Subject: Response to the U.S. Environmental Protection Agency Letters Dated February 27, 2015 and June 5, 2015 Regarding the 2014 Compliance Recertification Application

EPA Comment**2-46-1 CCA Appendix WRAC Waste Removal Documentation Needs Updating.**

**Title 40 CFR Part 191
Subparts B and C
Compliance Recertification Application 2014
for the
Waste Isolation Pilot Plant**

Figure WRAC-5. SWB and Seven-Pack Configurations

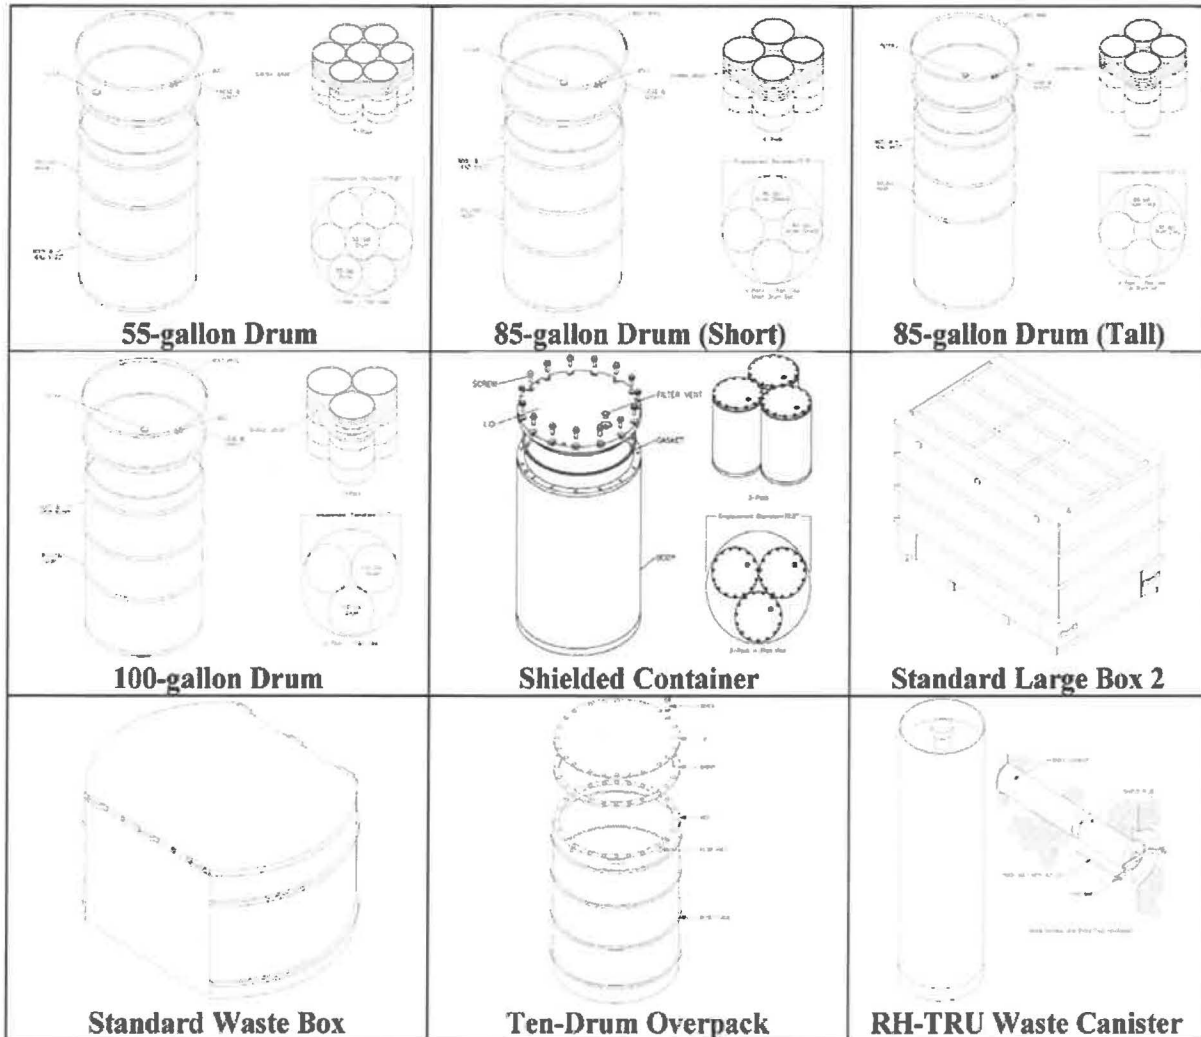
- *The waste containers have changed. The CCA assumed two principal types of containers (55-gallon drums and standard waste boxes) [CCA Appendix WRAC, page WRAC-8] but with the introduction of large waste boxes, shielded RH-TRU containers, pipe over packs, and super-compacted waste, these assumptions are no longer valid.*

See revisions to Section WRAC-5.0, page WRAC-8, lines 7-15, and Tables WRAC-1 and WRAC-2. See also Figure WRAC-5, Section WRAC-5.3, page WRAC-14, lines 13-17, and Section WRAC-7.0, page WRAC-18, lines 1-11.

Figure WRAC-6. WIPP Repository at Time of Closure

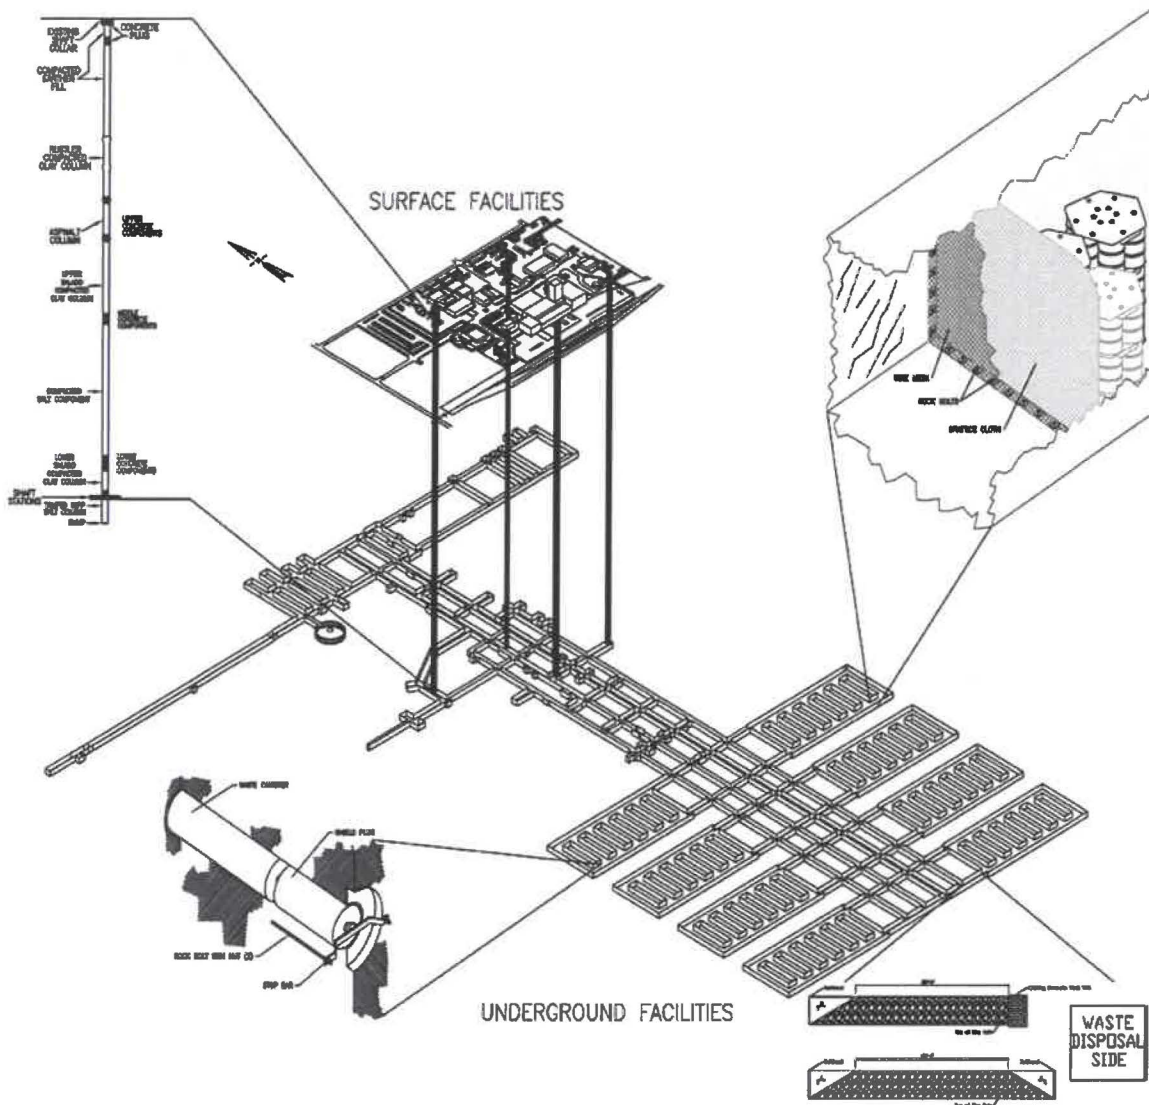
- *The waste characteristics have changed with the introduction of nitrate waste potentially subject to exothermic reactions.*
- *The run-of-mine salt panel closure replaced the original concrete-based Option D panel closure design, which can no longer be used "as markers for locating panels and drifts" [CCA Appendix WRAC, Section WRAC.6.4].*

See revisions to Section WRAC-5.0, page WRAC-8, lines 19-23; text concerning the Option D closure has been deleted. See also Figure WRAC-6.
